2 May 2013
Ref 12454

**PROPOSED RESIDENTIAL DEVELOPMENT
AVON ROAD & BEECHWORTH ROAD, PYMBLE
TRAFFIC AND PARKING MATTERS**

I refer to the RMS's letter dated 8 March 2013 requesting additional information in respect of the abovementioned development proposal. The following advice is provided in response to the traffic matters raised by the RMS:

EXISTING TRAFFIC VOLUMES
 FIGURE 1

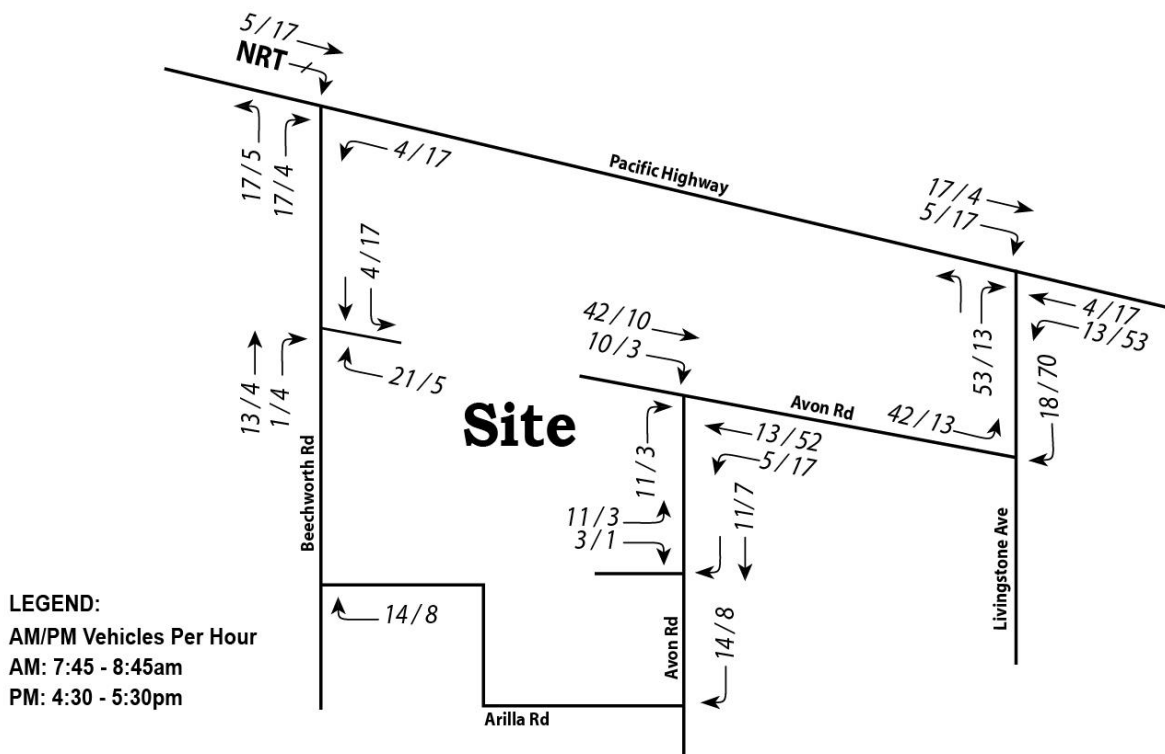
- e. An electronic copy of the SIDRA modelling will be forwarded to the RMS for their review, by email.
- f. The traffic modelling was based on the busiest one-hour period identified by the traffic surveys on the Pacific Highway. Those one-hour periods occurred between 7:45am-8:45am, and between 4:30pm-5:30pm when traffic volumes of up to 5300 vph were recorded on the Pacific Highway.

The traffic volumes used in this analysis are summarised on Figure 1 (Existing) and Figure 2 (Proposed) below:
